TRANS/WP.29/918
17 April 2003

DRAFT SUPPLEMENT 3 TO REGULATION No. 98

(Headlamps with gas-discharge light sources)

"Annex 4 - Appendix 1

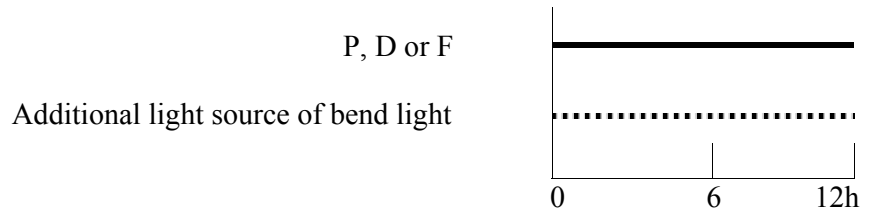
Annex 4, paragraph 1.1.1.1., add a new subparagraph (d) to read:

- "(d) In the case of a passing beam designed to provide bend lighting with the addition of a light source, this light source shall be switched on for 1 minute, and switched off for 9 minutes during the activation of the passing beam only (see annex 4 - appendix 1)."

Insert new Annex 4 - appendix 1, to read:
